Bulletin No.: PIP5203A

Service Bulletin

Subject: Poor Engine Performance P0089 P228D P0171 Whine Noise From High Pressure Fuel Pump

Models: 2010-2011 Buick LaCrosse
2011 Buick Regal
2010 - 2011 Chevrolet Equinox
2010-2011 GMC Terrain
Equipped with 4 cyl engine (RPO LAF)

3872270

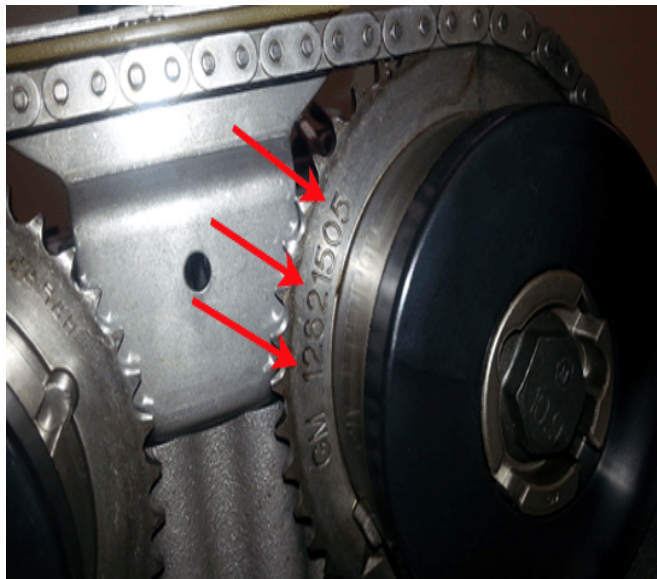
Below is an example of a 2011 intake camshaft actuator part number 12621505 and black in color (plastic cover piece).

3872269

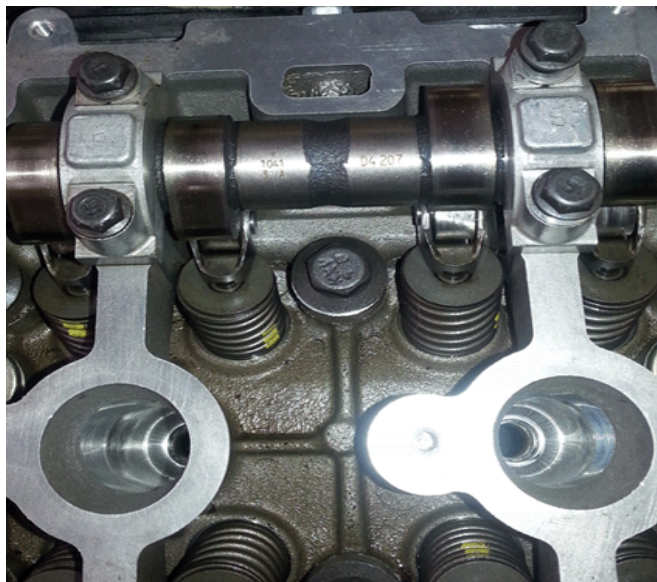
The camshafts can be identified by the last four digits of the part number located on a machined surface between the number 2 and number 3 cylinder camshaft lobes.

Below is an example of a 2011 intake camshaft part number 12634207.
